RS-10-148

Clinton Power Station, Unit 1
Facility Operating License No. NPF-62
NRC Docket No. 50-461

Subject: License Amendment Request for Adoption of Technical Specifications Task Force (TSTF) Traveler TSTF-501, Revision 1, Relocate Stored Fuel Oil and Lube Oil Volume Values to Licensee Control

Figure 1: Revised Division 1 Diesel Generator 6-Day Fuel Oil Storage Requirements

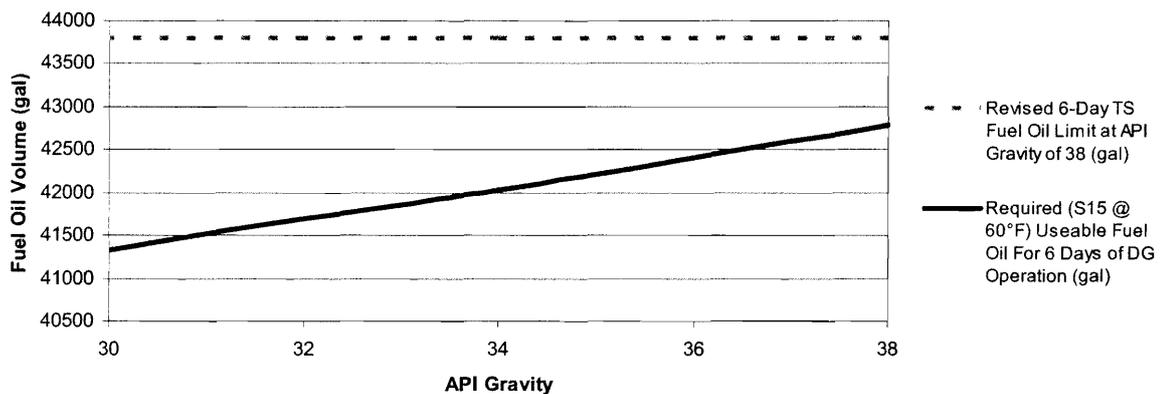
Additionally, fuel oil storage tank volumes are measured in gallons at CPS. Therefore, when determining the required number of gallons to meet the volumetric requirement for seven days and six days of Division 1 DG operation, EGC considered fuel oil with the lowest gross heat content per gallon (i.e., fuel oil with an API gravity of 38) from the range of API gravities allowed by the CPS Diesel Fuel Oil Testing Program. To determine the required amount of fuel oil to operate the Division 1 DG for seven days and six days, EGC conservatively used the maximum Division 1 DG post-LOCA load demand and applied it for the entire 7-day and 6-day periods to determine fuel oil consumption rates and storage requirements. As shown in Figures 1 and 2 below, there is considerable margin between the amounts of ultra-low sulfur diesel fuel oil (i.e., S15 @ 60 °F) determined to be needed to operate the Division 1 DG at the maximum post-LOCA load for six days and seven days and the proposed revised 6-day and 7-day fuel oil volume requirements as shown in the attached markup of the TS Bases Section 3.8.3. Moreover, margin exists over the entire range of API gravities allowed by the CPS Fuel Oil Testing Program.

The fuel oil level equivalent to a 6 day supply for the Division 1 DG is 43,810 gallons, for the Division 2 DG is 38,572 gallons, and for the Division 3 DG is 25,286 gallons.
